**City of Avondale Estates  
Planning Architectural Zoning Board  
Staff Review, Variances \***

**November 17, 2025, PAZB Meeting**

**Applicant:** Maple 278 Ventures LLC: Jetha Wagner, Avila Development

### Avila Hedgewood Avondale Estates Maple Street Parcel

WASHINGTON ST EXT.

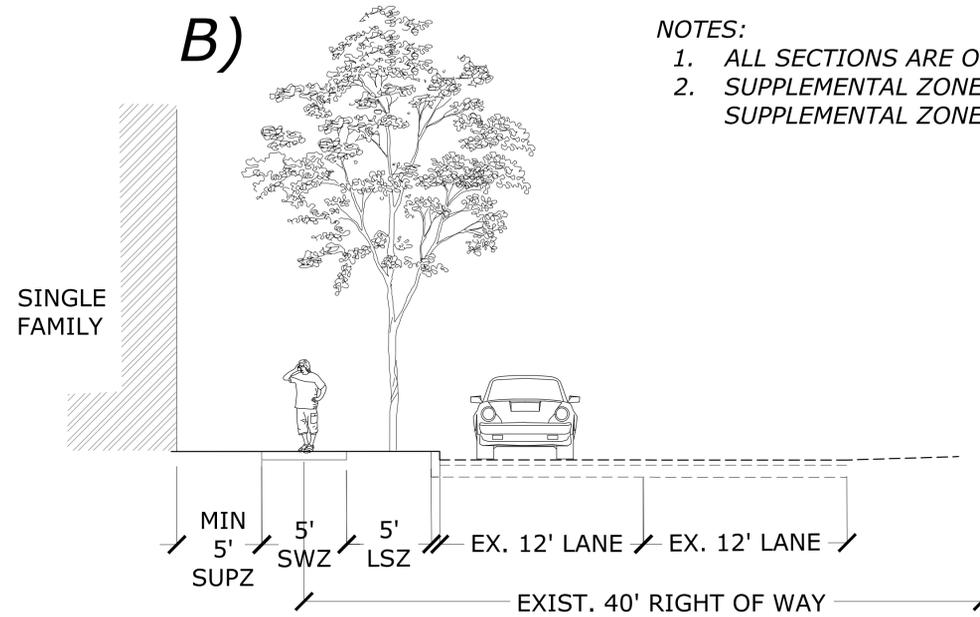
A) Washington Street Extension east- New street w/ 90 degree parking- (new public)  
 FROM: Figure 21-3.2.8.B.4.d and Table 3.2.8.E reduce type D street section from 40' ROW and 5' SUPZ to building face.  
 TO: Washington Street extension-new varied section with 30' ROW (5' LSZ, 12' lane, 12' lane) and 3' to 4' LSZ with a retaining wall to the north, and an 18.5' parking bay, 5' SWZ, and 5' SUPZ to building face per section in Exhibit D.

OLIVE STREET (NORTH OF POTTER)

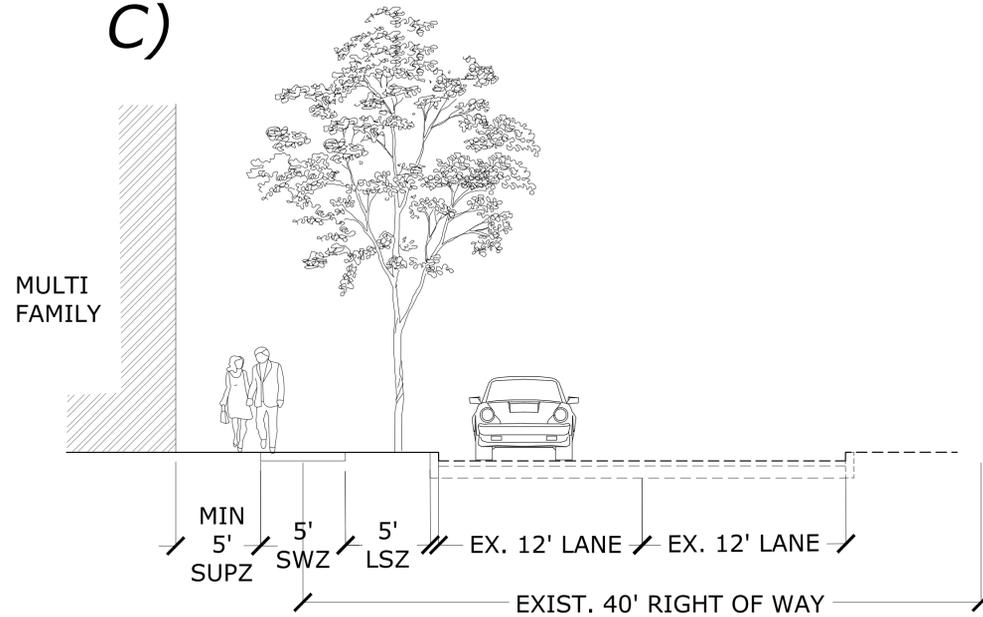
B) Olive Street-North of Potter Street (existing public) - No ROW Variance Needed, only variation in layout of street elements.  
 FROM: Figure 21-3.2.8.B.4.c and Table 3.2.8.E reduce type C3 street section from 40' ROW, 2' additional LSZ and 5' SUPZ to building face.  
 TO: Olive Street- North of Potter Street section with 40' ROW and 3' additional SWZ and 5' SUPZ to single family building face per section in Exhibit D.

OLIVE STREET (SOUTH OF POTTER)

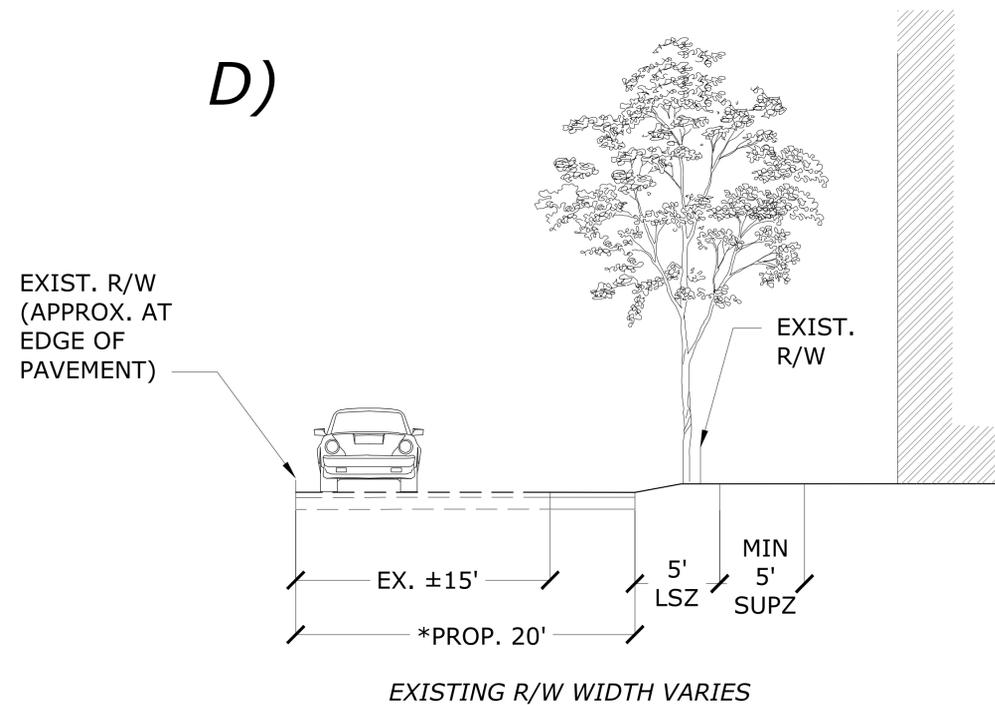
C) Olive Street-South of Potter Street (existing public) -No ROW Variance Needed, only variation in layout of street elements.  
 FROM: Figure 21-3.2.8.B.4.c and Table 3.2.8.E realign type C3 street section from 40' ROW, 2' additional LSZ and 5' SUPZ to building face.  
 TO: Olive Street- South of Potter Street section with 40' ROW and 3' additional SWZ and 5' SUPZ to multifamily building face per section in Exhibit D.

MAPLE STREET

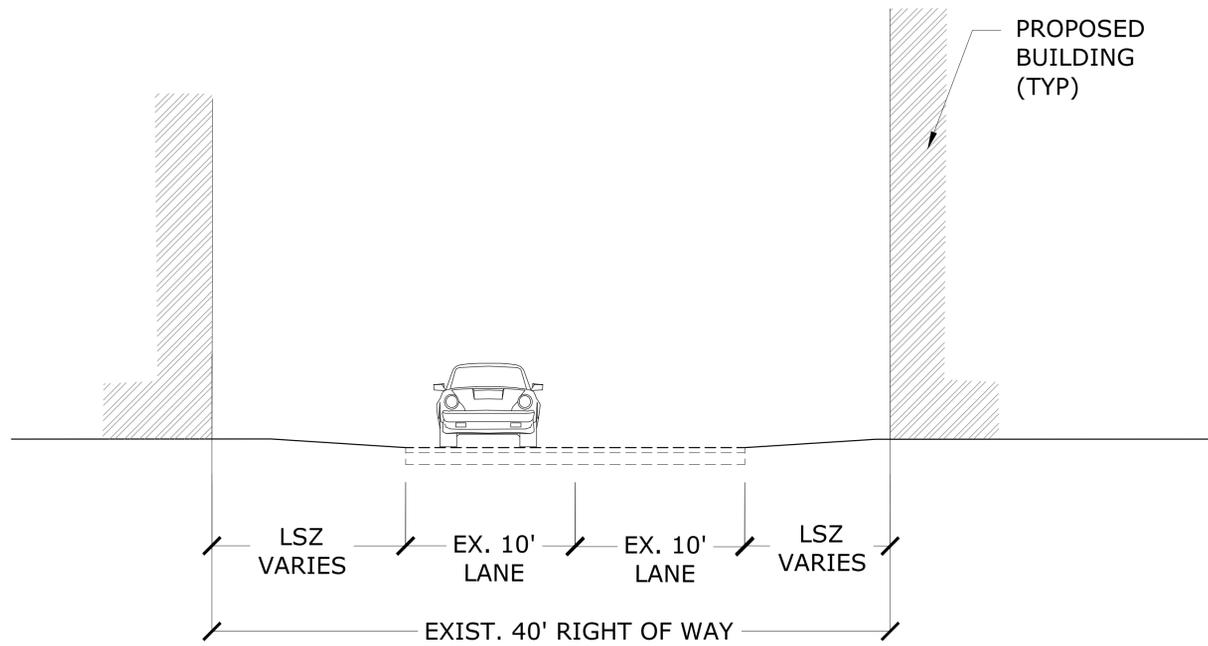
E) Maple Street- (existing public)  
 FROM: Figure 21-3.2.8.B.4.c and Table 3.2.8.E reduce type C2 street section from 40' ROW, 5' SWZ, and 5' SUPZ to building face.  
 TO: Maple Street- section with 26' ROW (1.75' LSZ, 11.25' lane, 11.25' lane, 1.75' LSZ) and 3.25' additional LSZ, 5' SWZ, and 5' min. SUPZ to multifamily building face per section in Exhibit D.

E. COLLEGE AVE.

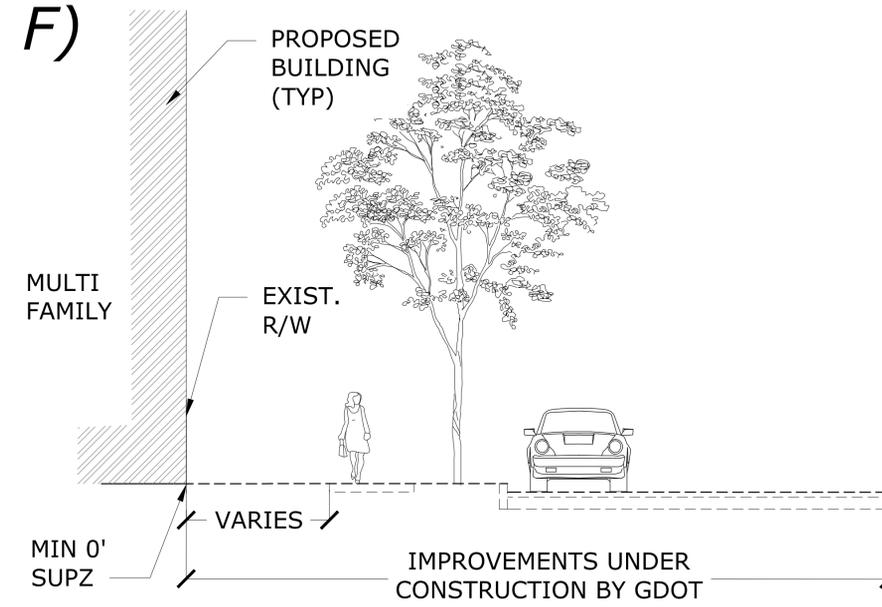
F) East College Avenue- (existing public)  
 FROM: Table 3.2.8.E reduce type A street section from 10' SUPZ to building face.

TO: East College Avenue - section with existing ROW and streetscape improvements, and 0' min. SUPZ to multifamily building face per section in Exhibit D

**Figure 3.2.12.F - Transitional Height Plane**

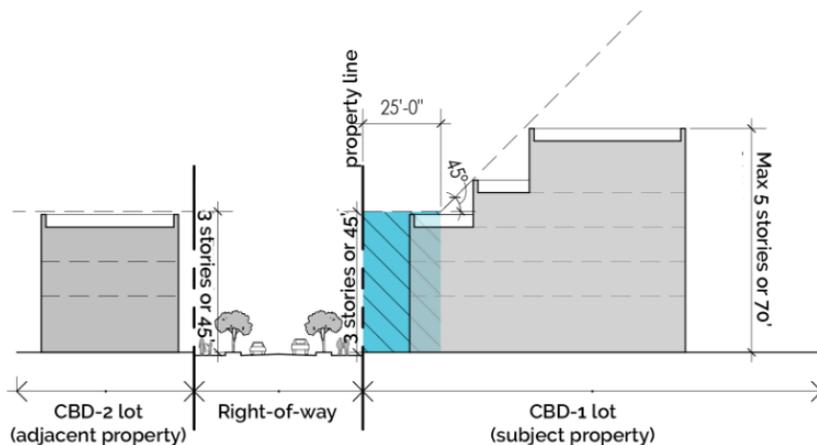
**DESIGN TEAM NOTE:** This requirement impacts the Southeastern corner of the Maple Street site, which abuts the CBD-2 district across Olive Street. This would limit that portion of the building to 3-stories (instead of 5) which could eventually step up to 5-stories. See Figure 3.2.12.F below. Need to be allowed 5-stories (plus basement) in all locations – including areas where transitional height plan comes into play.

1. When adjacent to sensitive uses, the maximum height of all buildings or structures in the CBD shall be 45 feet or three (3) stories, whichever is less, for a horizontal distance of 25 feet from the property line in toward the subject lot. At the point 25 feet into the property, the height of the building can increase at a 45 degree angle up to a maximum height of 70 feet or five (5) stories, whichever is less, depending on the maximum height of the sub-area.
2. No building or portion of building may protrude above the transitional height plane.  
**DESIGN TEAM NOTE:** Need to be allowed 5-stories (plus basement) in all locations – including areas where transitional height plan comes into play.

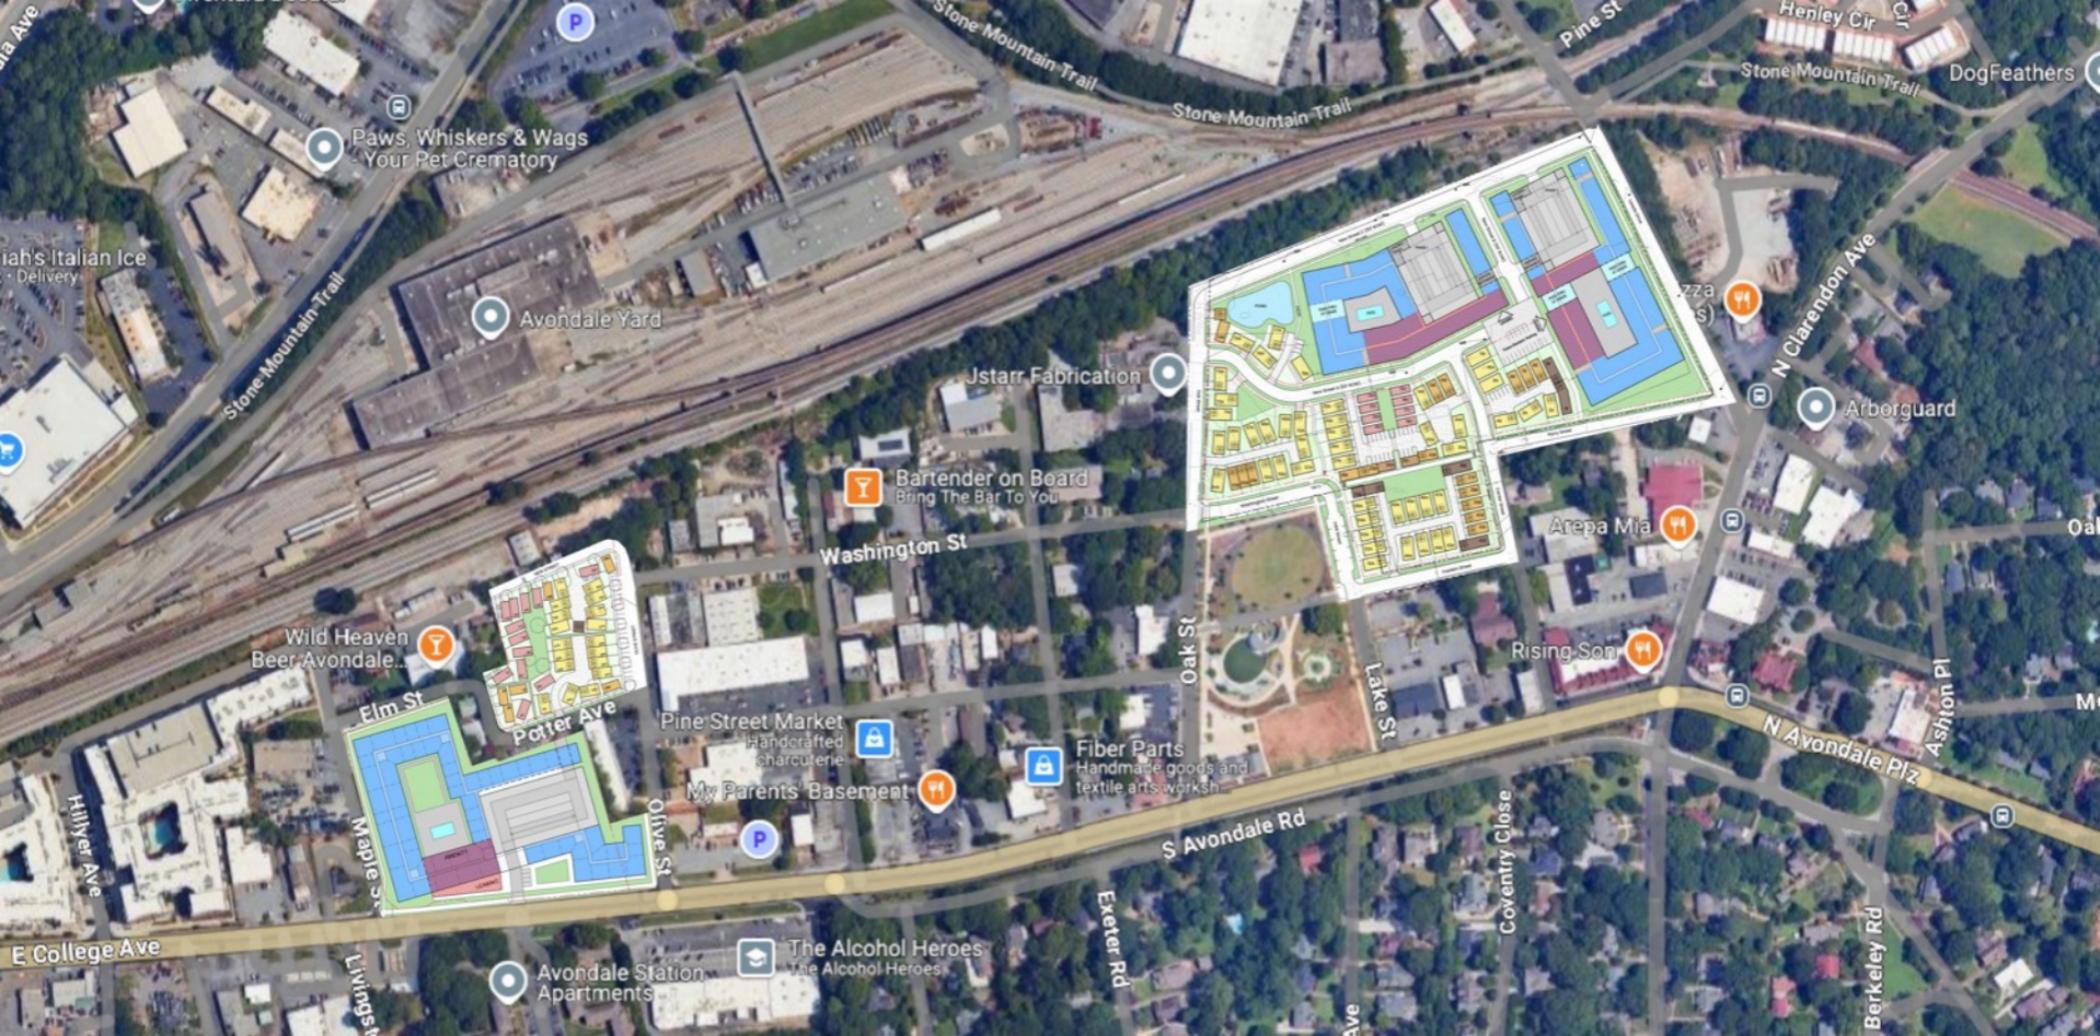
**DESIGN TEAM NOTE:** Precast parking garages have a 10'-8" floor-to-floor dimension to align with adjacent residential levels, resulting in a vertical clearance of less than 10'. Need to eliminate this vertical height requirement.
